NUMBER: 07-89-15R DATE: 02-10-15

APPLICABILITY: 2015-16MY Legacy and Outback Models

Interior Fuse Box (F/B) "IG" and "ACC" Relay

Replacement for Engine Will Not Crank / Start Condition

OLD: M07

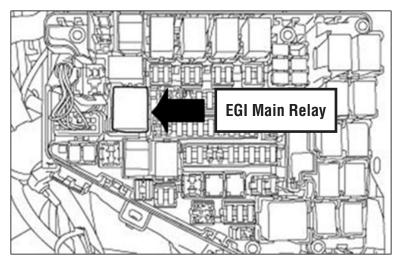
IMPORTANT: Relay identification:

The photos above show the IG1, IG2, ACC1 and ACC2 relays. The EGI Main Relay photos are shown below.

NEW: M09
